CZECH SPORT AIRCRAFT	<h1>SERVICE BULLETIN</h1>	Czech Sport Aircraft a.s. Na Záhonech 212, 686 04 Kunovice Czech Republic office@czechsportaircraft.com	
		No.: SB-SC-043	Rev.: -
		Date: 2017-10-03 Page: 1 of 6	Date: -

MODEL AFFECTED:	SportCruiser
SUBJECT:	Modification of the Aircraft Category Setting
AIRCRAFT AFFECTED:	All SportCruiser aircraft equipped with Dynon SkyView System with integrated transponder SV-XPNDR-261/262, see the list in the Supplement No.1.
COMPLIANCE:	Completion of this Service Bulletin is mandatory and must be performed as soon as possible. Instructions, if not followed, may lead to incorrect aircraft category identification by the ADS-B Performance Monitor system.

Figure 1 – SETUP MENU

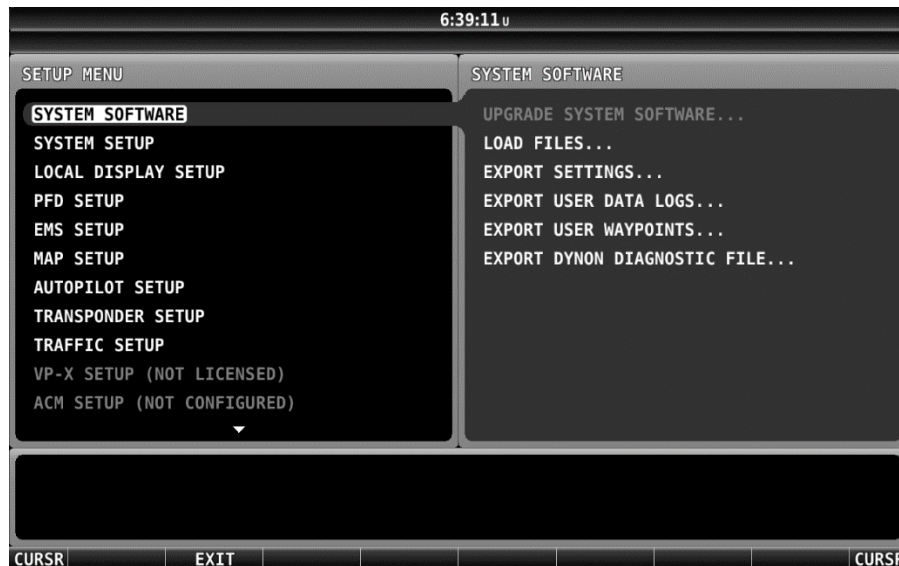
1. Move the aircraft to a suitable place to perform the work.
2. Remove the engine upper cowling (see the SC-AMM-1-0-00, the latest revision).
3. Connect a suitable aircraft battery charger (4A or higher) to the aircraft battery poles. Turn the charger on.
4. Turn the "MASTER BAT", "EFIS1", "EFIS2" (if installed) and the "AVIONICS" switches on and wait until the display/displays boots/boot up.
5. Push the buttons 7 + 8 (from the left) on the EFIS 1 display simultaneously for a few seconds to enter the SETUP MENU, see Fig. 1.

Figure 2 – Transponder Setup link

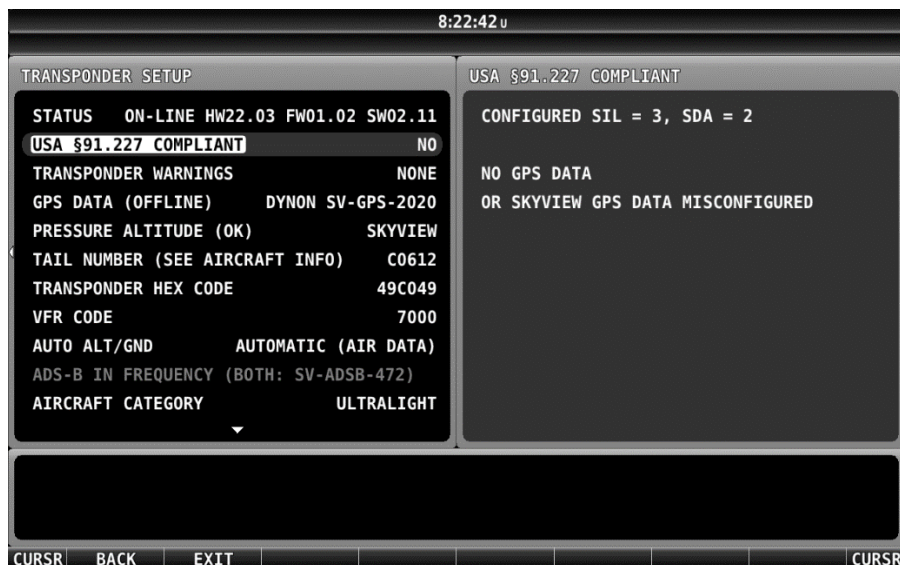
- Use the left or the right joystick on the EFIS 1 display, roll down to the TRANSPONDER SETUP (see Fig. 2) and press the joystick to enter this setup, see Fig. 3.
